**MEP RENOVATIONS - EARL HALL
SOUTHERN CONNECTICUT STATE UNIVERSITY
NEW HAVEN, CONNECTICUT
PROJECT: BI-RS-248**

BID OPENING	1:00 P.M.	DECEMBER 22, 2009
ADDENDUM NUMBER ONE	DATE OF ADDENDUM	DECEMBER 14, 2009

SKP-1

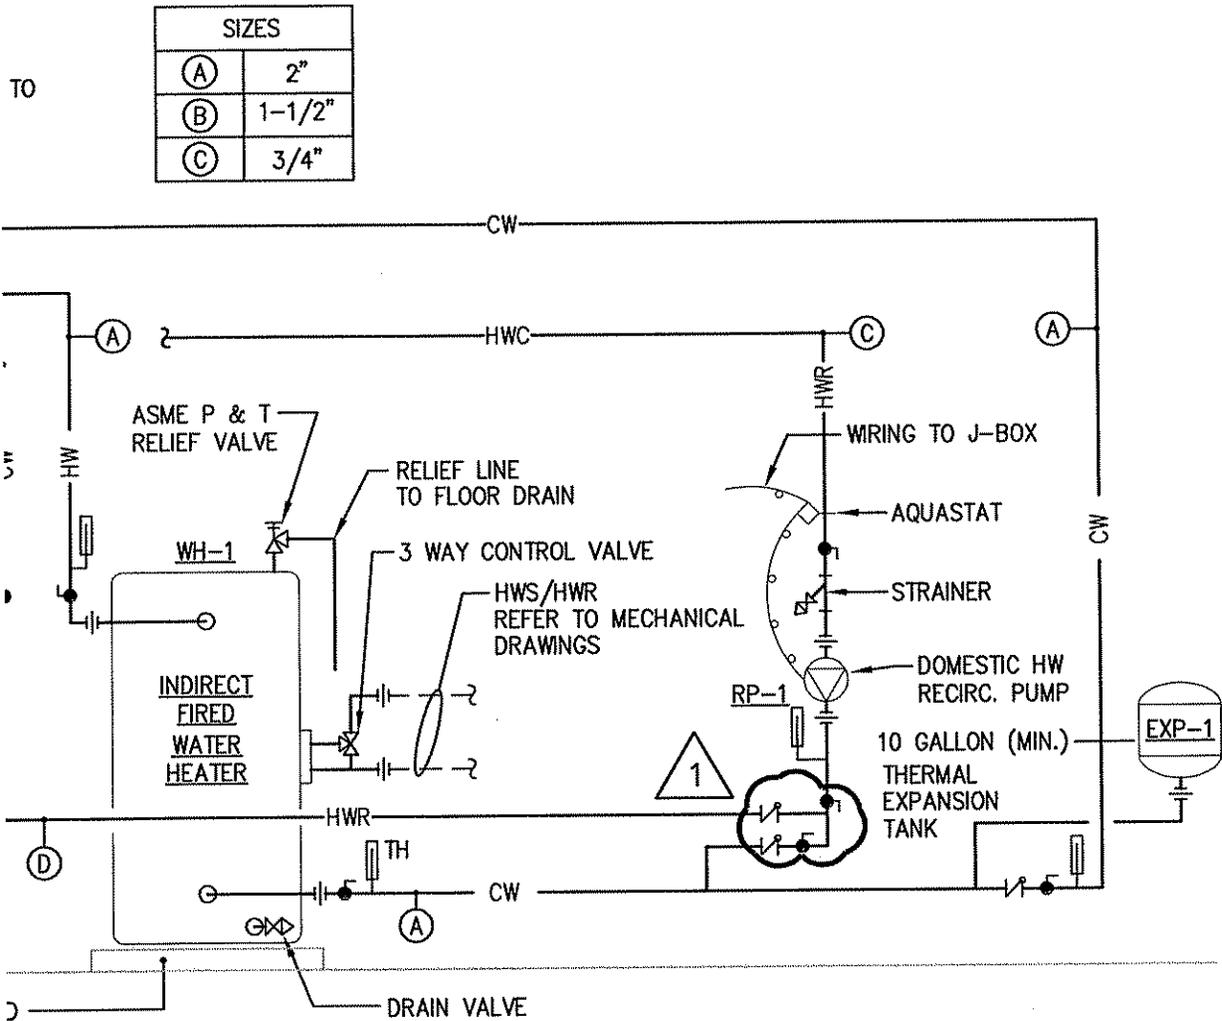
DRAWING: P-201 Detail 2: Water Heater Piping Diagram

Revised the detail. Refer to SKP-1.

DRAWING NO:
SK-A1
 DATE: 12-10-09
 SCALE: AS NOTED

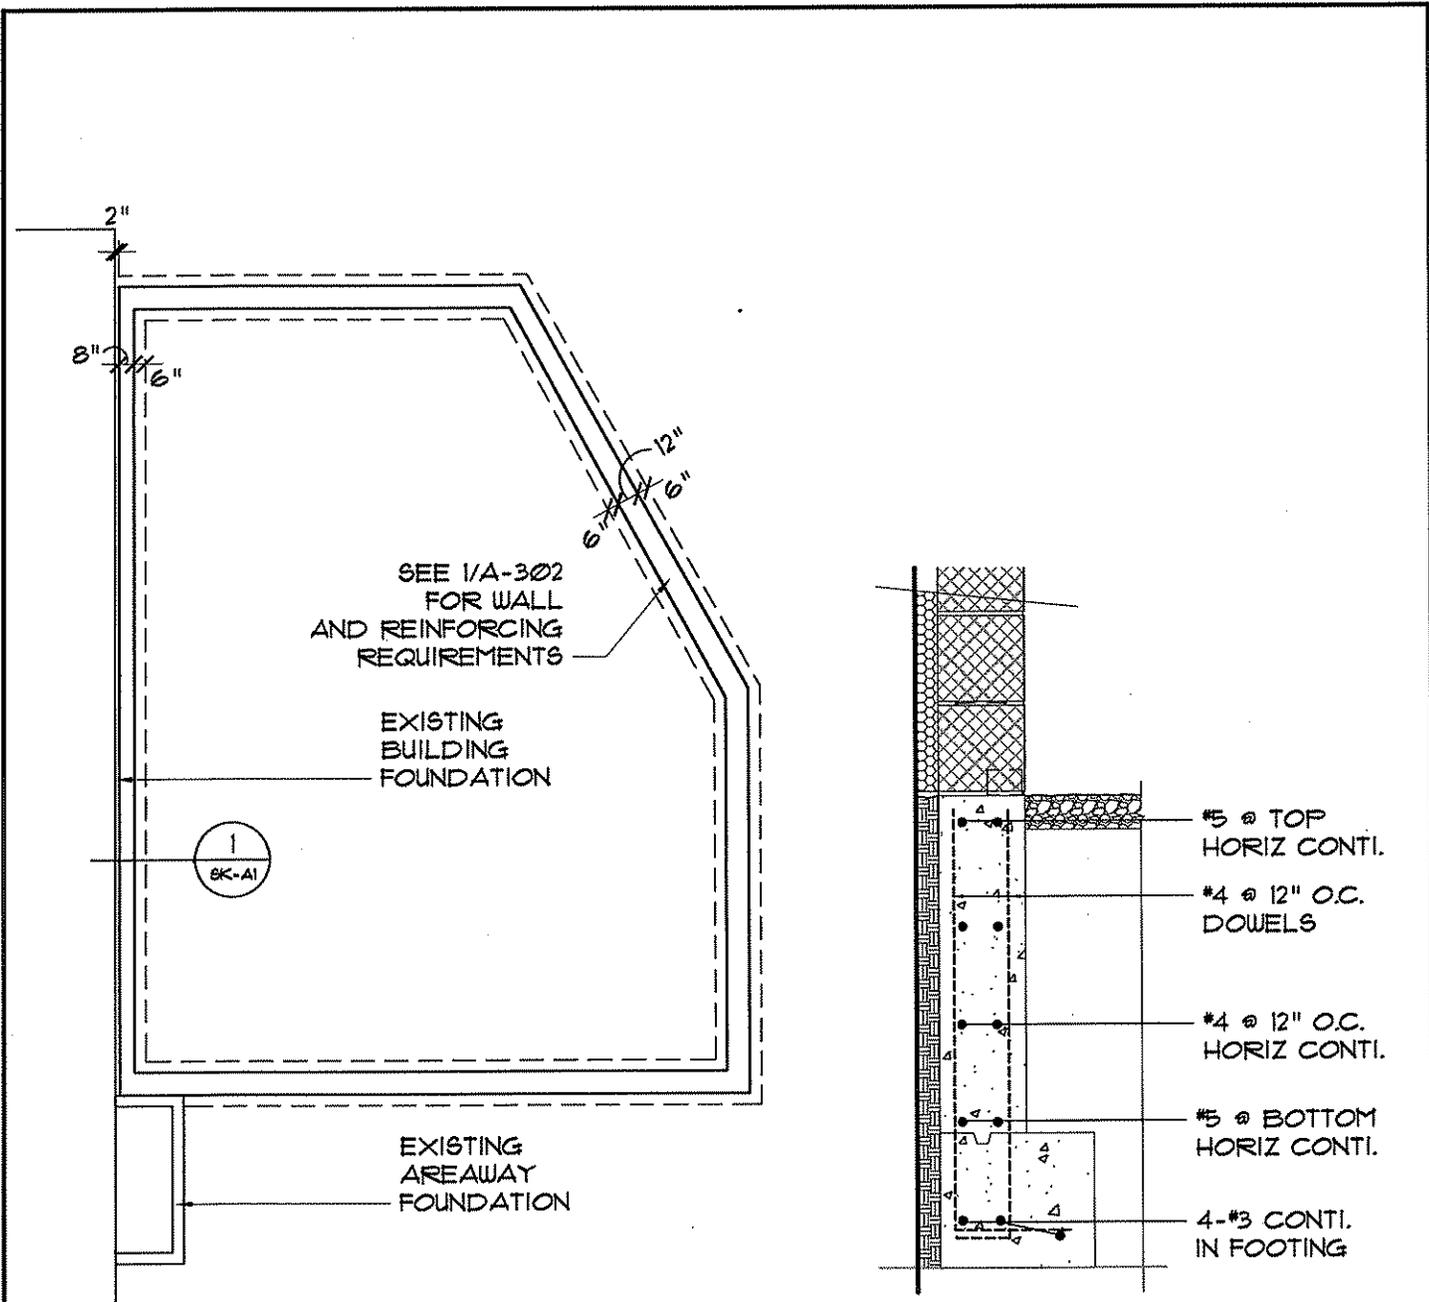
Can you please confirm the foundation requirements at the chiller enclosure as illustrated on 7/a-302 along the existing building. The section only addresses the CMU wall, not the concrete. It doesn't seem likely that a foundation already exists in this area.

Please see attached SK-A1 for foundation requirements for the chiller enclosure.

SKF-1

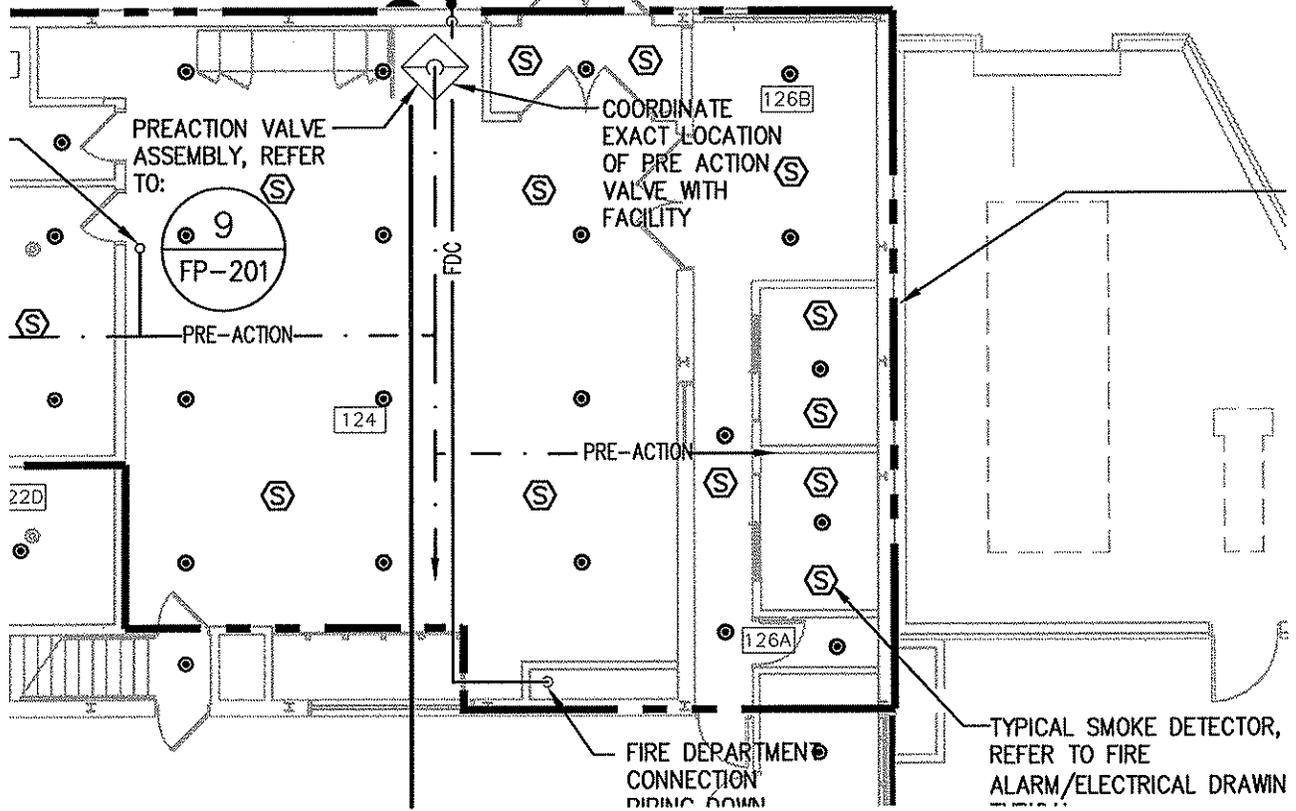
Request: The above referenced drawings show conflicting information for the proposed Fire Department Connection. Sheet 100 specifies 6-inch piping and FDC whereas FP-101 calls for a 4-inch FDC and piping. Please Clarify.

The fire department connection shall be 6", the drawings shall be revised accordingly. Refer to fire protection sketch SKF-1.

NEW 2 1/2" x 2 1/2" x 6" FIRE DEPARTMENT CONNECTION WITH CUSTOM SIGNAGE "TO BUILDING SPRINKLERS" COORDINATE EXACT LOCATION AND TYPE WITH LOCAL FIRE MARSHAL. FDC PIPING SHALL BE PITCHED BACK TOWARDS BUILDING CHECK VALVE, OTHERWISE PROVIDE DRY WELL
